U.S. Environmental Protection Agency
November 2012

**Responses to Public Comments on the Proposed
Prevention of Significant Deterioration Permit
for the Pio Pico Energy Center**

Figure 1 - Location of correctional facilities with respect to the Project at the 2km and 5km radii.

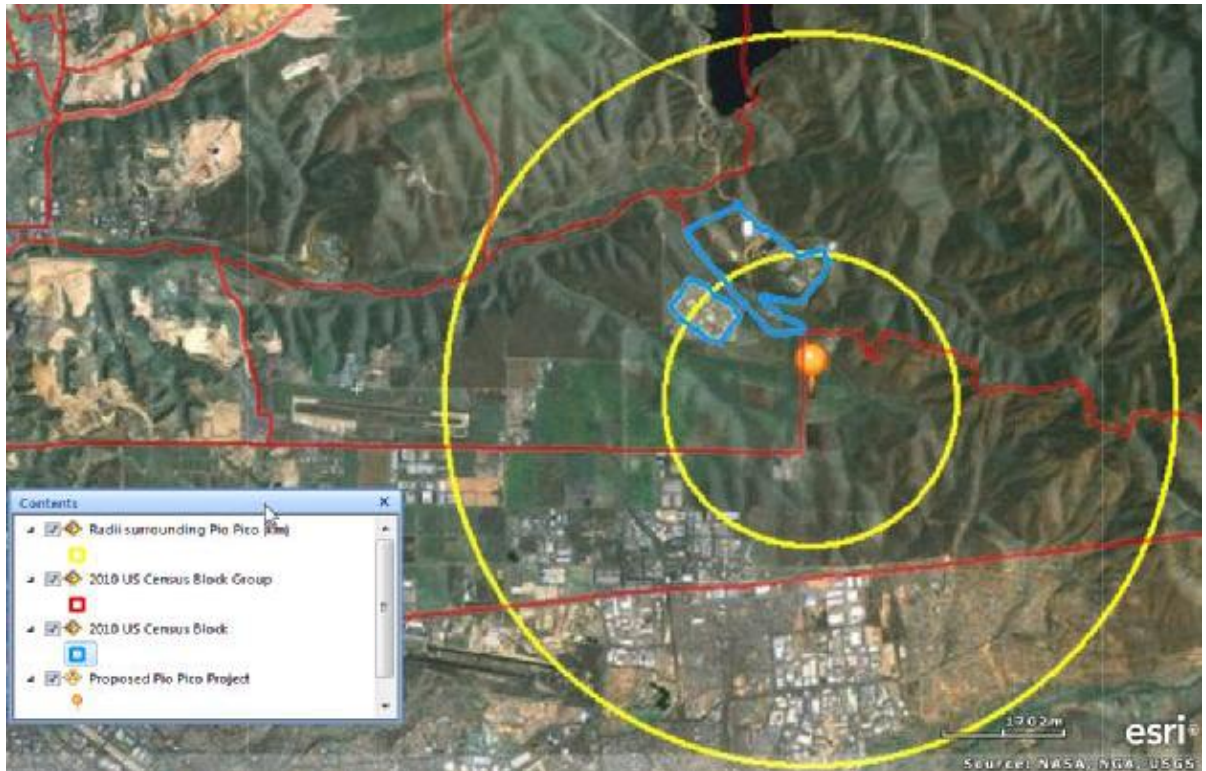
Our EJ Analysis considered demographic information at the 5km radius, which fully included the prison population as well as the surrounding population.³¹ See Figure 1 below. Due to resolution limits of the census data used to generate the analysis, data from the 2010 census and 2000 census was derived assuming uniform population distribution with inclusion of the entire prison population. The percentages included in the demographics

This conclusion extends to EPA's consideration of the populations at the correctional facilities given that the NAAQS are health-based standards, designed to protect public health with an adequate margin of safety, including sensitive subpopulations. We are not aware of information, nor has the commenter presented any specific information, indicating that the environmental or health conditions faced by the prison population would call into question this conclusion.
